**MONTGOMERY COUNTY HISTORIC PRESERVATION COMMISSION**  
**STAFF REPORT**

<b>Address:</b>	7309 Piney Branch Rd., Takoma Park	<b>Meeting Date:</b>	2/12/2019
<b>Resource:</b>	Contributing Resource <b>Takoma Park Historic District</b>	<b>Report Date:</b>	2/6/2019
<b>Review:</b>	HAWP	<b>Public Notice:</b>	1/30/2019
<b>Case Number:</b>	37/03-19D	<b>Tax Credit:</b>	Partial
<b>Applicant:</b>	Natalie Hopkins	<b>Staff:</b>	Dan Bruechert
<b>Proposal:</b>	Building Addition, Door Replacement, and Porch Modifications

Figure 2: Rear elevation showing the outline of the previous and revision for the dormer.

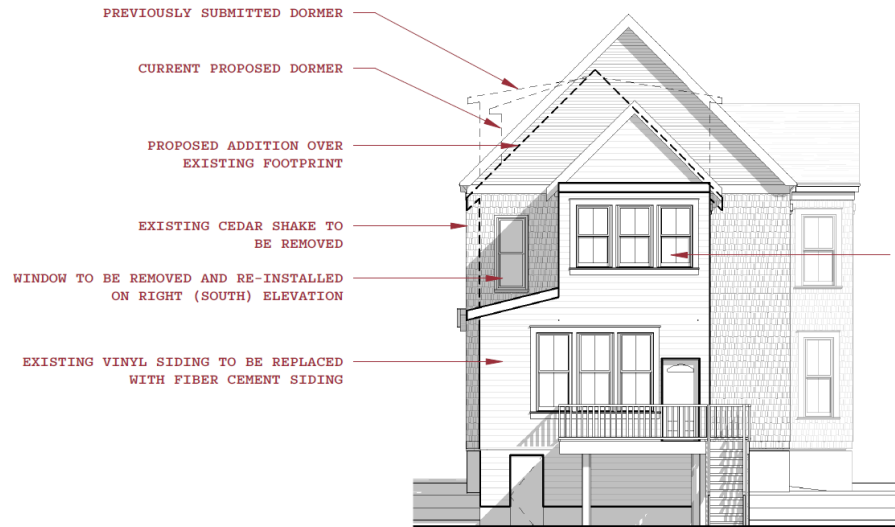
The proposed addition will be constructed above the footprint of the c.1960 and 2006 additions at the rear. These additions are inset by 13" (thirteen inches) from the right historic wall plane and are inset by several feet from the left wall. The view of the addition from the left is further obscured by the bay window on the left elevation. The gable roof of the addition will be 4' 6" (four feet, six inches) lower than the historic gable roof. The proposed addition will provide access to all three floors of living space. This will be accomplished in the 3<sup>rd</sup> floor by adding a large shed dormer to both sides of the dormer. At the preliminary consultation the HPC determined that the dormer on the left side of the house would not detract from the historic appearance of the house and would support approval of this element at the HAWP stage. In revising the proposal for the right side of the addition the applicant encountered feasibility and cost challenges with matching the eave height, so in order to reduce the visual impact of the dormer, the applicant took the following steps:

- Inset south wall of dormer 21" from the exterior walls below
- Reduced dormer width from 16'-0" to 14'-6"
- Reduced wall plate height and increased slope of south roof
- Shifted entire dormer to rear. Previous design was ±4'-9" from existing roof, current proposal is ±6'-9" from existing roof.

The HPC's initial recommendation was to raise the eave line and increase the pitch of the roof. This would have provided significantly more clearance in the third floor. The other alternative recommended was to inset the dormer from the wall plane and to move it further to the rear. The applicant indicated that raising the eave was not feasible and instead raised the dormer roof pitch, brought the dormer in by 21" (twenty-one inches), and shifted the dormer to the rear by an additional 2' (two feet). Staff finds that this change significantly reduces the visual impact of the dormer from the previous proposal. The submission reviewed by the HPC at the prelim not only proposed a taller dormer that was closer to the right of way, but also created a four-story vertical wall plane which had the effect of increasing the massing of the rear addition. By reducing the size of the dormer and pulling it away from the wall plane, the impact the dormer has on the historic building and surrounding district is significantly reduced. Staff finds that dormer is compatible with the historic house in size, scale, and massing supports approval under 24A-8(b)(2).

## PROPOSED REAR ELEVATION

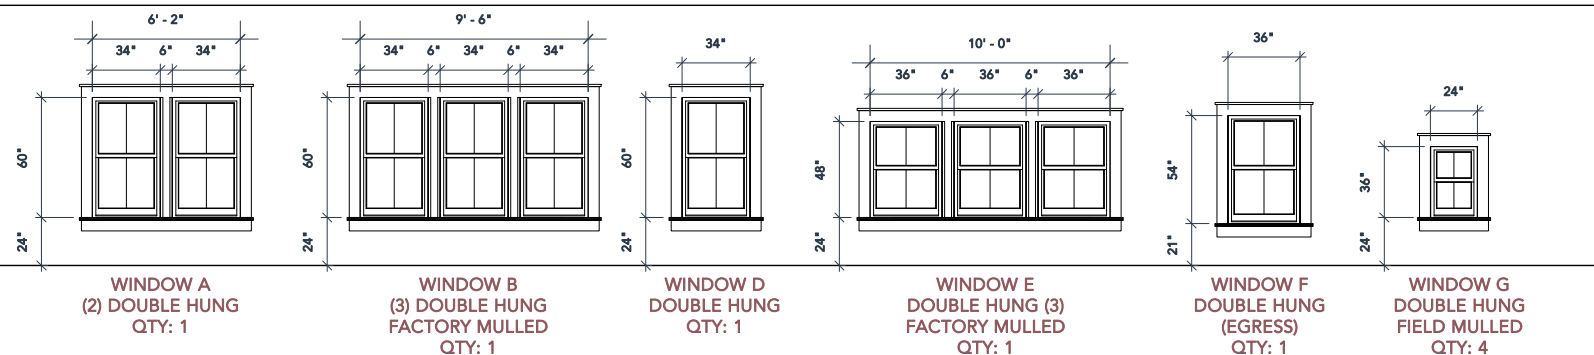
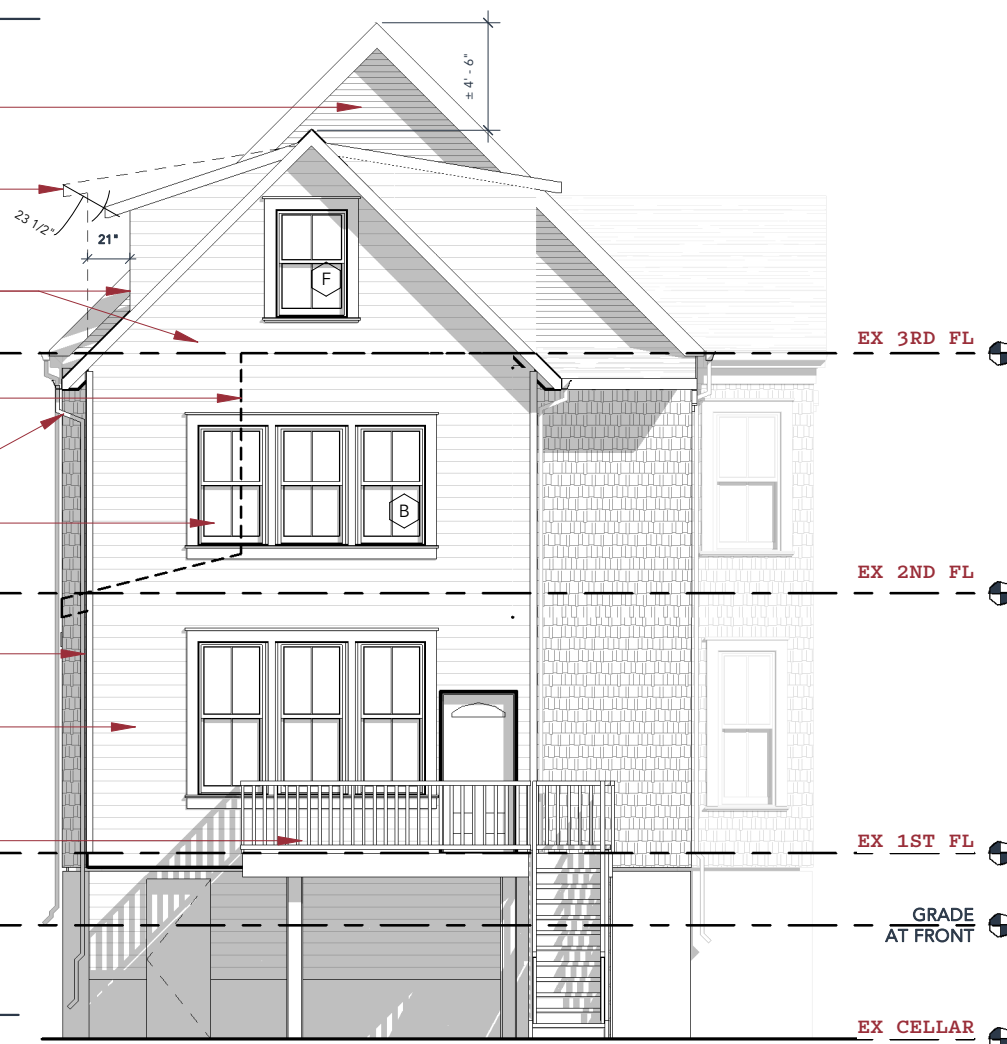
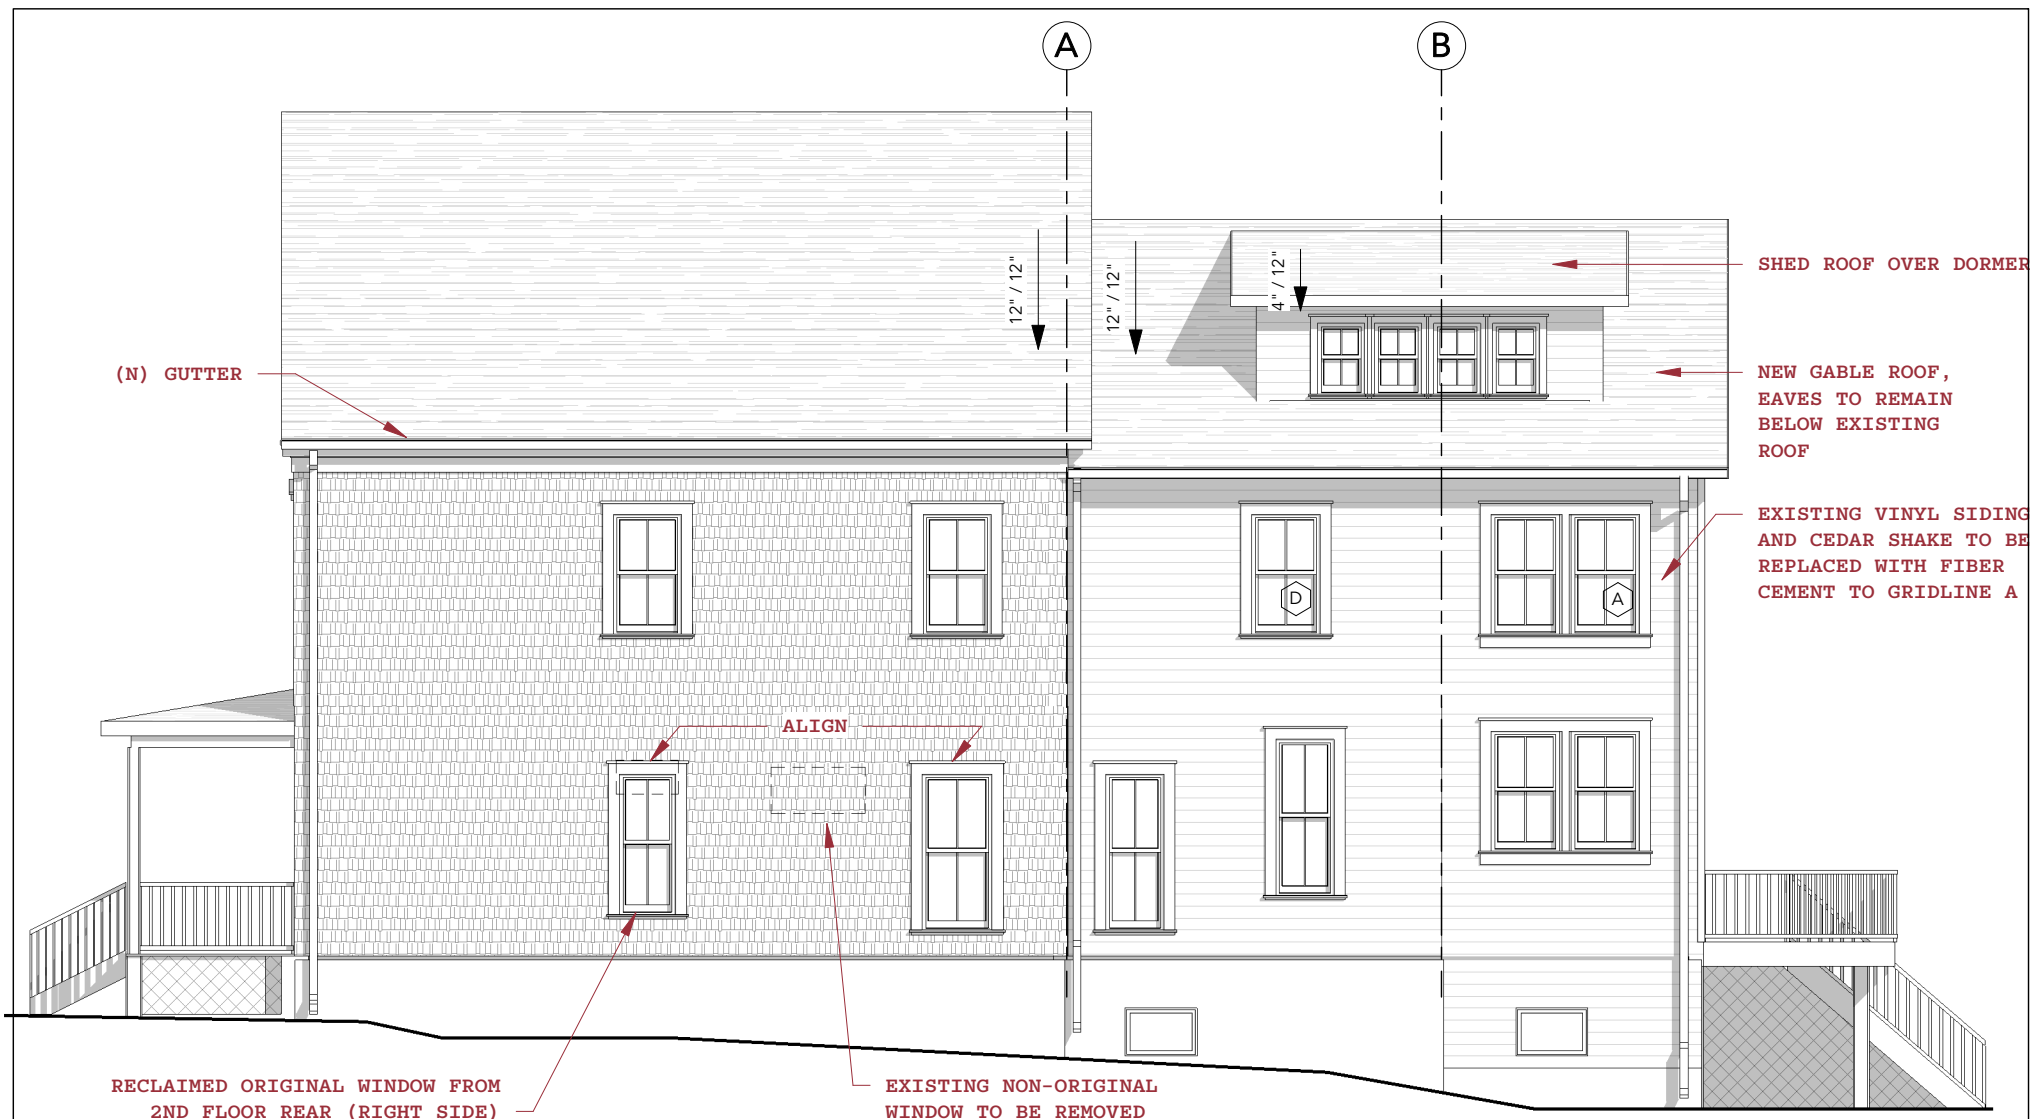
The windows proposed for the new addition are all two-over-two Andersen 200 series vinyl-clad wood windows. This configuration is found throughout the historic house and Staff finds the lite pattern to be compatible. Staff, however, does not find the material to be appropriate for the Takoma Park Historic District, as the HPC has not approve vinyl clad wood windows on additions to contributing buildings. Staff recommends the HPC approve the proposed window locations and configuration, but include the condition for approval that the windows be wood or aluminum clad wood windows. The exterior of vinyl windows is too flat to be compatible and - especially when coupled with Hardi siding - does not provide adequate shadow lines or depth on new construction to be compatible with the historic. Staff and the HPC have consistently determined that wood or aluminum clad wood windows have sufficient depth to be compatible on additions to contributing buildings in the Takoma Park Historic District.

Staff recommends the HPC approve the addition with the added condition for approval that the windows be either wood or aluminum clad wood windows. Detailed specifications need to be submitted to Staff for verification prior to permitting.

1. The proposed vinyl clad wood windows are not an appropriate material. The approved windows in the addition need to be wood or aluminum clad wood windows. Detailed specifications for the windows need to be submitted to Staff for verification prior to permitting.
